KEATING
OF CHICAGO, INC. ®

RELAY REPLACEMENT INSTRUCTIONS

REPLACING PART# 030845 WITH PART# 058684

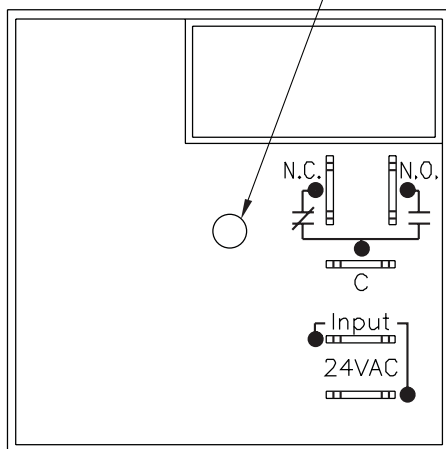
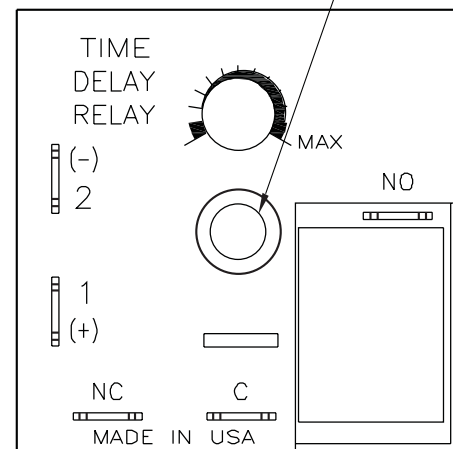
This kit is for the replacement of a time delay relay with one that has the same function, but the locations of the connection points are different and they are also labeled differently.

0.17" MOUNTING HOLE

0.25" MOUNTING HOLE

PART #	030845	058684
FUNCTION		
SUPPLY VOLTAGE	INPUT 24VAC	1(-)
SUPPLY VOLTAGE	INPUT 24VAC	2(+)
OUTPUT	C	C
OUTPUT	NO	NO
OUTPUT	NC	NC

1. Remove the old relay and replace it with the new one.
2. Move the wires from the old relay to the new one, follow the connection chart.
